RE: RCRA Former Storage Area - Proposed Sampling Plan, Amphenol

The New York State Department of Environmental Conservation (Department) has reviewed the proposed work plan to sample and characterize the soils beneath the former container storage area. The Department approves the Work Plan with the stipulation that a current picture of the location be sent to this Office when the winter conditions allow.

FIGURE 1 PAST FACILITY LAYOUT SCALE: 1"= 300' 12/5/83

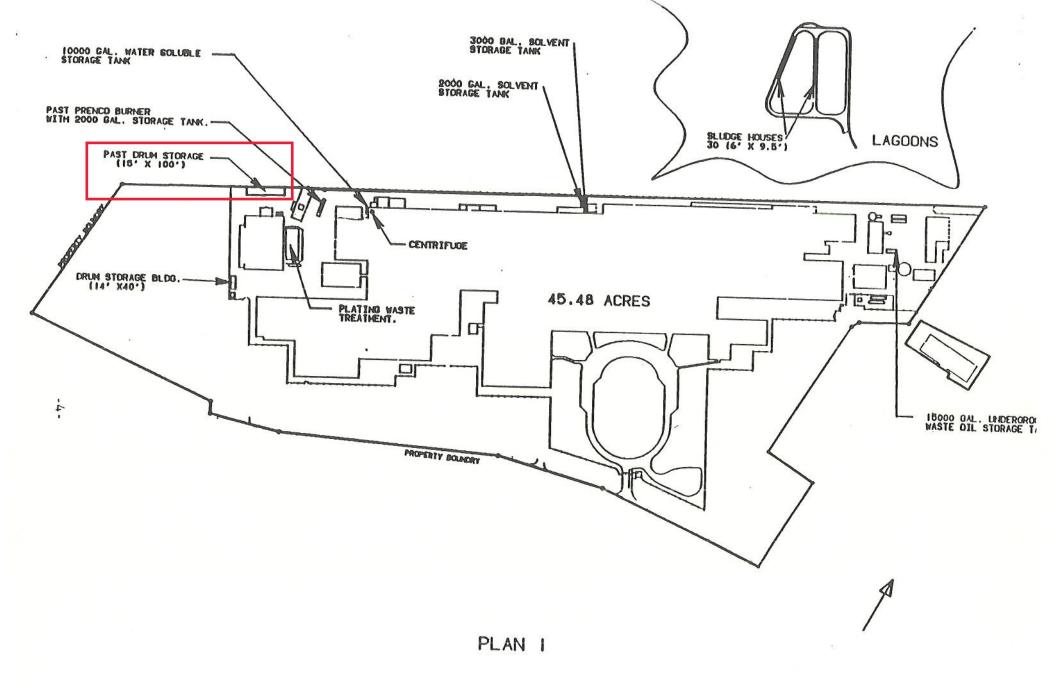
The former container storage area (see the attached Figure 1 from the Versar report), located north of the plating building, is now completely paved and part of an alley used for raw material delivery. The area described by Versar is approximately 15 feet by 100 feet with the site boundary fence immediately on the north side of the area.
